Planning Commission Staff Report

Subject: CUP Amendment Vote Report

Petition: P.Z. 11-2008 The Willows at Brooking Park

Re: P.Z. 11-2008 The Willows at Brooking Park Village-06/12/08 Submittal (207-4243)

Sheet Number:
PSP-1

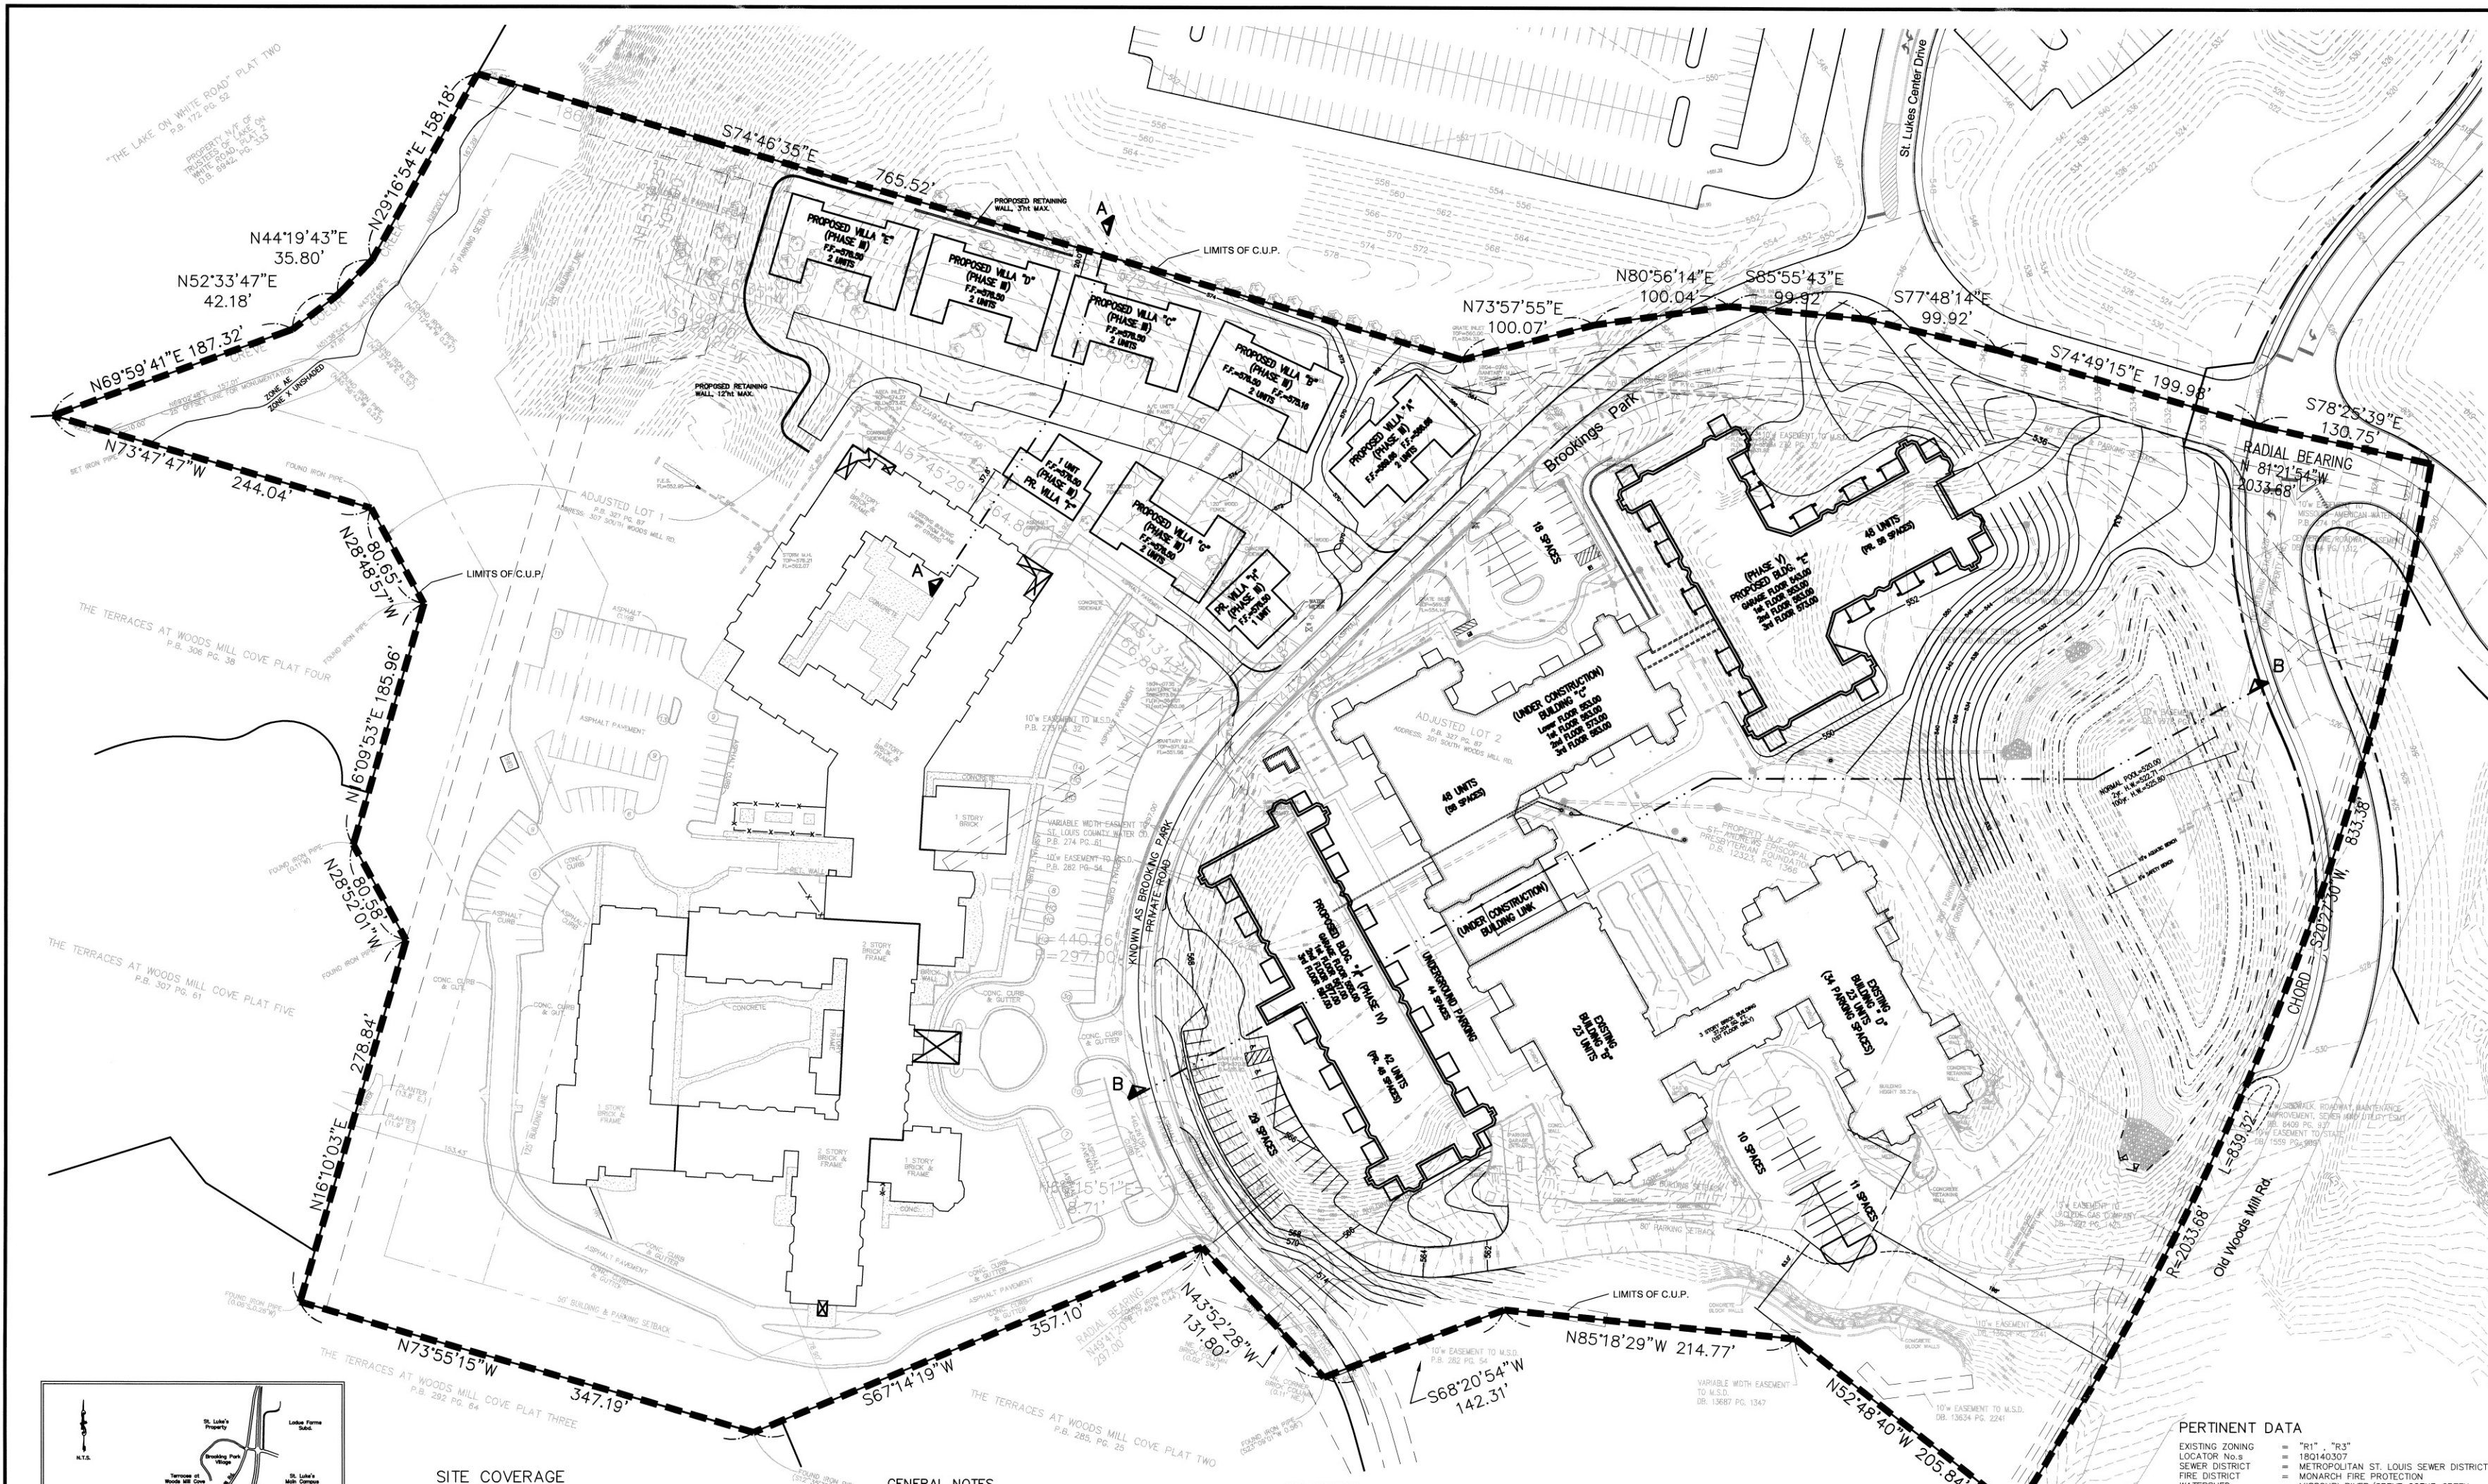
2. Can the reduced parking setback along the southern side of the property be limited to only the area of the site that includes the conversion of the mini round-a-bout to the eleven (11) additional parking stalls?

3. The proposed twenty-nine (29) stall parking lot adjacent to Building "A" does not meet the requested sixty-three (63) foot parking setback from the south limits of the CUP development. Note, the existing parking lot on lot 1 also does not meet the requested sixty-three (63) foot parking setback.

7. The footprints of the buildings on lot 2 do not match the previously approved Amended Site Development Section Plan, approved on March 31, 2006 and recorded in Book 354, pages 218 and 219. Missing is the proposed "link" between buildings "B" and "C".

8. The proposed roadway cul-de-sac is located too close to the existing structure to the south. The close proximity poses a potential hazard to vehicles traveling around the circle.

9. The retaining wall along the perimeter of the cul-de-sac will require extensive geotechnical analysis and certification as to the stability of the wall since it appears that the wall will also serve as structural support of the roadway, which may require additional requirements.

10. the retaining wall also is located fairly close to the houses. Please be advised that if a geogrid system is used for structural support for the wall, a larger separation will be required between the wall and the houses to allow for the geogrids.

Response: Yes, we would like to only change the setback requirements in that area where we are proposing the additional spaces.

Response: We would like to only change the setback requirements in that area where we are proposing the additional spaces, so it would not affect those parking spaces.

Response: The plan has been revised to label the building link.

Response: Plan has been revised using a "T" type turn-a-round for the emergency vehicles instead of the before shown cul-de-sac.

Response: Noted, Engineer will review design under construction documents.

Response: Noted, Engineer will review design under construction documents.
